The Commission has issued the enclosed Amendments Nos. 107, 107, and 104 for Licenses Nos. DPR-38, DPR-47 and DPR-55 for the Oconee Nuclear Station, Units Nos. 1, 2 and 3. These amendments consist of changes to the Station's common Technical Specifications (TSs) in response to your request dated January 12, 1982.

These amendments revise the TS requirements concerning heatup, cooldown and inservice testing limitations for the reactor coolant system.

ATTACHMENT TO LICENSE AMENDMENTS

SAFETY EVALUATION BY THE OFFICE OF NUCLEAR REACTOR REGULATION  
SUPPORTING AMENDMENT NO. 107 TO FACILITY OPERATING LICENSE NO. DPR-38  
AMENDMENT NO. 107 TO FACILITY OPERATING LICENSE NO. DPR-47  
AMENDMENT NO. 104 TO FACILITY OPERATING LICENSE NO. DPR-55  
DUKE POWER COMPANY  
OCONEE NUCLEAR STATION, UNITS NOS. 1, 2 AND 3  
DOCKETS NOS. 50-269, 50-270 AND 50-287

OCONEE UNIT 1 REACTOR COOLANT  
SYSTEM NORMAL OPERATION-HEATUP  
LIMITATIONS APPLICABLE FOR FIRST  
15.0 EFFECTIVE FULL POWER YEARS  
OCONEE NUCLEAR STATION  
Figure 3.1.2-1A

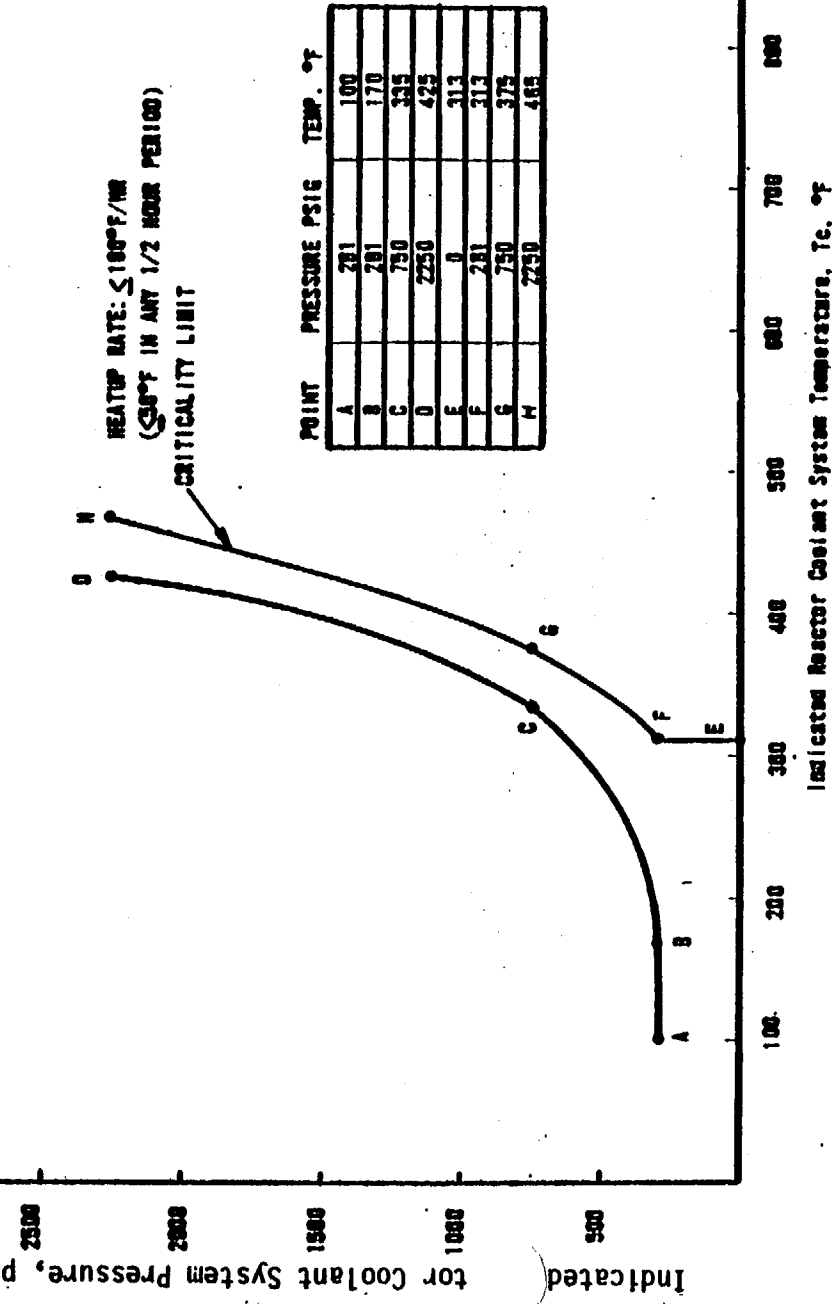
Replace the following pages of the Appendix "A" Technical Specifications with the attached pages. The revised pages are identified by amendment numbers and contain vertical lines indicating the area of change.

By letter dated January 12, 1982, Duke Power Company (Duke or the licensee) submitted an application to revise the normal operation heatup and cooldown limitations and the inservice testing heatup and cooldown limitations for the Oconee Nuclear Station, Units 1, 2 and 3 (ONS 1, 2 and 3). The existing Technical Specifications (TSs) contain Figures indicating the allowable pressure/temperature relationships for heatups and cooldowns which are stated to be applicable for the first 6, 5 and 5 effective full power years (EFPY) for the ONS 1, 2 and 3 respectively. As of January 1, 1982, the reactor vessel service life was 5.08, 4.82 and 4.36 EFPY for the ONS 1, 2 and 3 respectively. The proposed Figures are to be applicable for the first 15 EFPY for each ONS Unit.

THE ACCEPTABLE PRESSURE-TEMPERATURE COMBINATIONS ARE BELOW AND TO THE RIGHT OF THE LIMIT CURVE(S). THE LIMIT CURVES INCLUDE THE PRESSURE DIFFERENTIAL BETWEEN THE POINT OF SYSTEM PRESSURE MEASUREMENT AND THE PRESSURE ON THE REACTOR VESSEL CONTROLLING THE LIMIT CURVE. THEY INCLUDE AN ADDITIONAL MARGIN OF SAFETY FOR POSSIBLE INSTRUMENT ERROR (25 PSI AND 10°F). THE REACTOR MUST NOT BE MADE CRITICAL UNTIL THE PRESSURE-TEMPERATURE COMBINATIONS ARE TO THE RIGHT OF THE CRITICALITY LIMIT.
